Access Compliance Report

Public Rights-of-Way

Intersection ID: 13369	Main Street: N_I-77_RA	Cross Street: WEST_BV	Location: S
ADA ID: E4456F21DAA6	Ramp Type: Para	Initial Pass/Fail: Fail	Overall Compliance: No
		Severity Score: 35

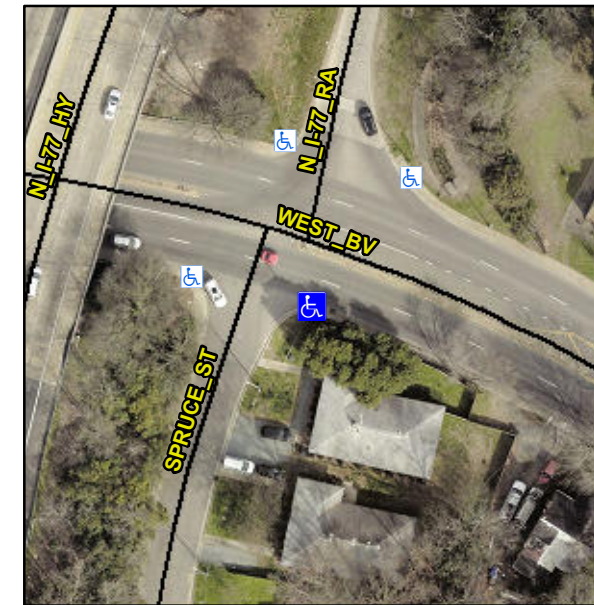
R304.5.1, R304.3.2, R304.5.3

Compliance	Description	Data	Compliance	Description	Data
N/A	Ramp Length LT (in)	50.0	N/A	Ramp Length RT (in)	N/A
No	Ramp Width LT (in)	42.0	N/A	Ramp Width RT (in)	N/A
No	Ramp Slope LT (%)	15.0	N/A	Ramp Slope RT (%)	N/A
No	Ramp XSlope LT (%)	4.4	N/A	Ramp XSlope RT (%)	N/A
N/A	Landing Length (in)	N/A	N/A	DWS Provided?	N/A
N/A	Landing Width (in)	N/A	N/A	DWS Contrast?	N/A
N/A	Landing Slope (%)	N/A	N/A	DWS Length (in)	N/A
N/A	Landing X Slope (%)	N/A	N/A	DWS Full Width?	N/A
N/A	Landing Curb? (Y/N)	N/A	N/A	DWS Offset (in)	N/A
N/A	Shared Landing?	N/A			
N/A	Gutter Ponding?	N/A	N/A	Gutter Slope (%)	N/A
N/A	Gutter Lip Ht (in)	N/A	N/A	Gutter X Slope (%)	N/A
N/A	Painted X Walk1?	No	N/A	Painted X Walk2?	N/A
	X Walk 1 Direction	To NW		X Walk 2 Direction	N/A
N/A	X Walk 1 Width (in)	N/A	N/A	X Walk 2 Width (in)	N/A
	X Walk 1 Slope (%)	0.9		X Walk 2 Slope (%)	N/A
	X Walk 1 X Slope (%)	2.7		X Walk 2 X Slope (%)	N/A
N/A	Ramp inside XWalk1?	N/A	N/A	Ramp inside XWalk2?	N/A

Remove & Replace Entire Ramp.
